Road Safety Audit

Sturt Highway – Waikerie

May 2018

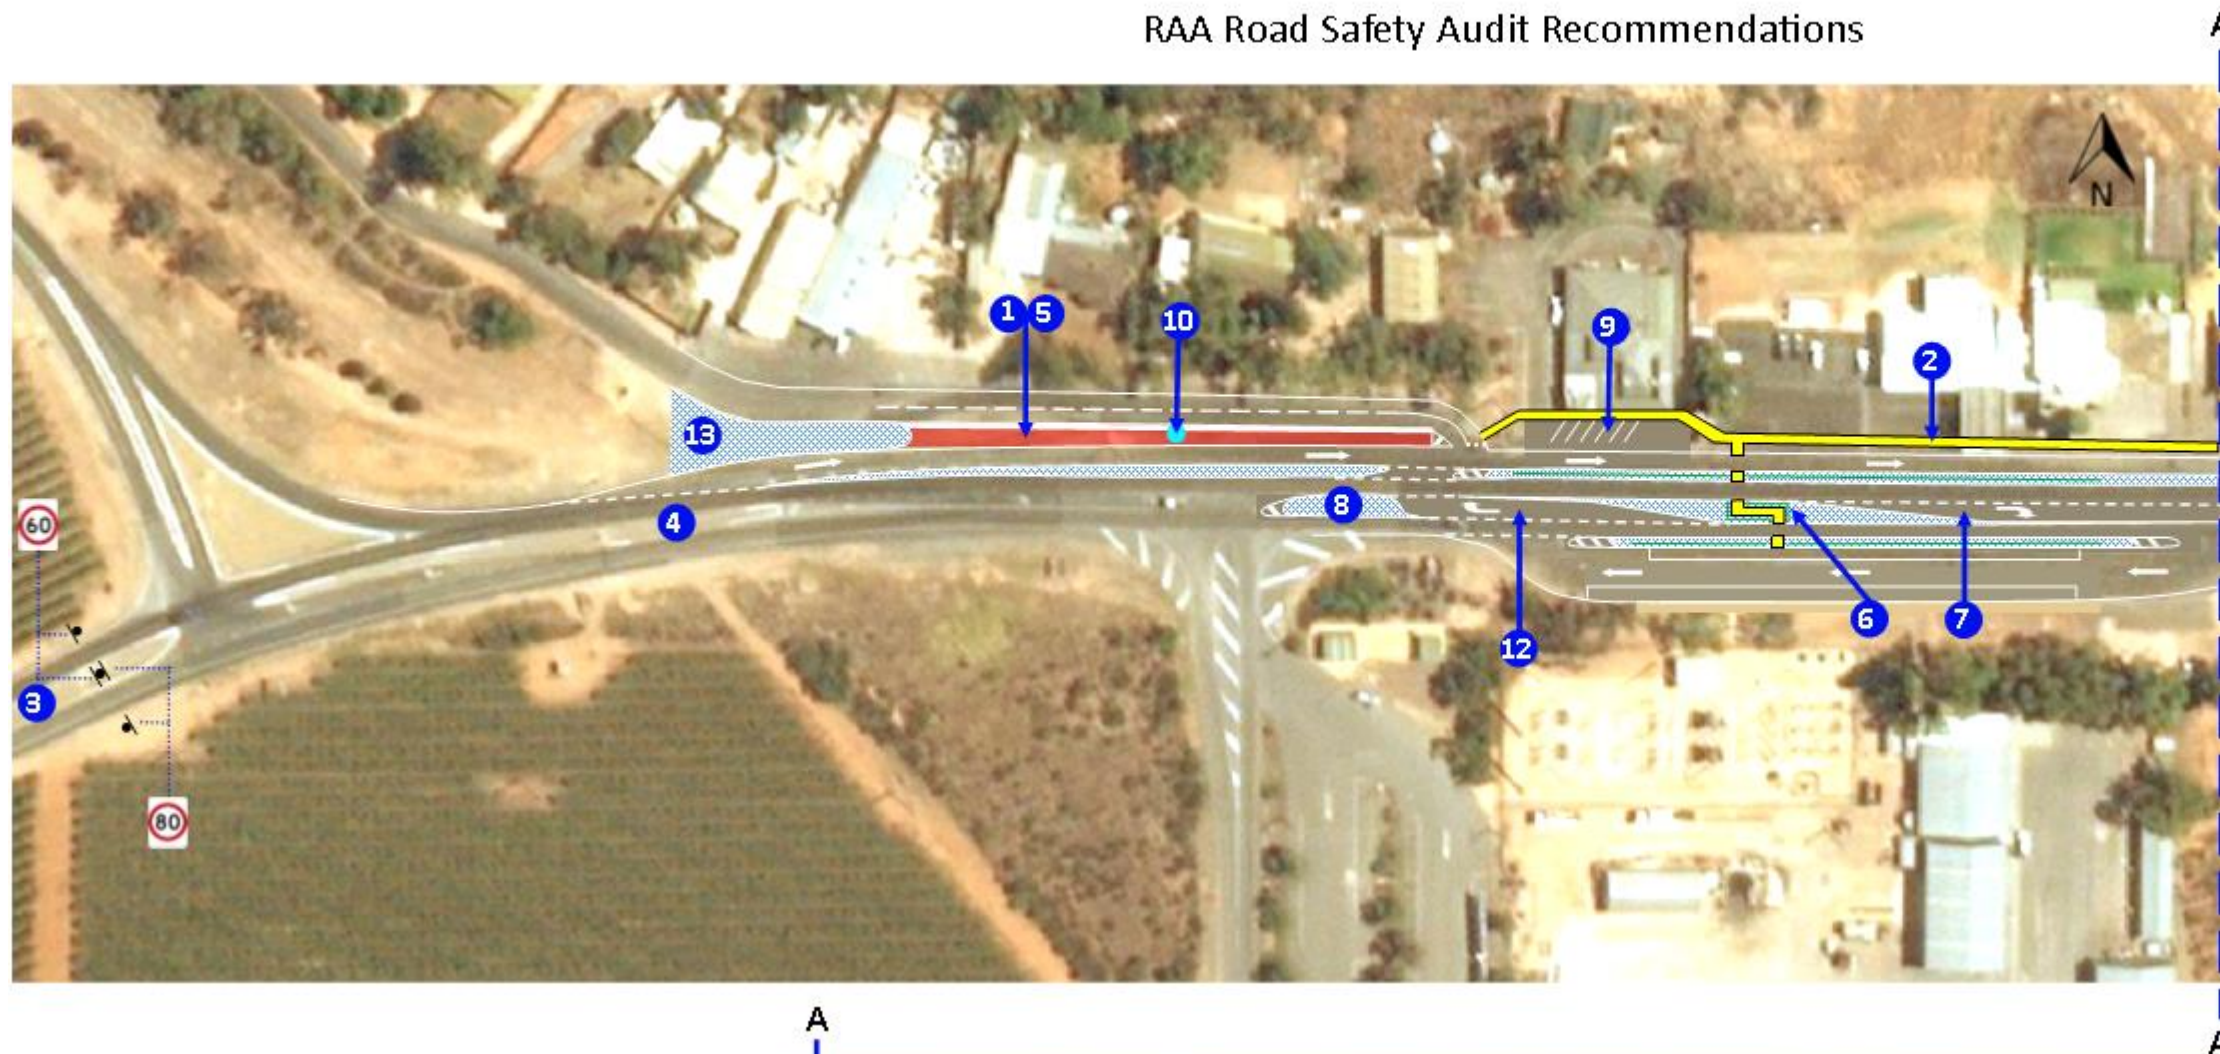
| Item No. | Recommendation | Risk Rating | Road Authority Response/Comments | Road Authority Decision |
|----------|---|-------------|----------------------------------|-------------------------|
| 6. | Install pedestrian refuges and fencing as part of a raised concrete median scheme | A | | |
| 7. | Extend channelized right turn lane into Growers Wine Group | B | | |
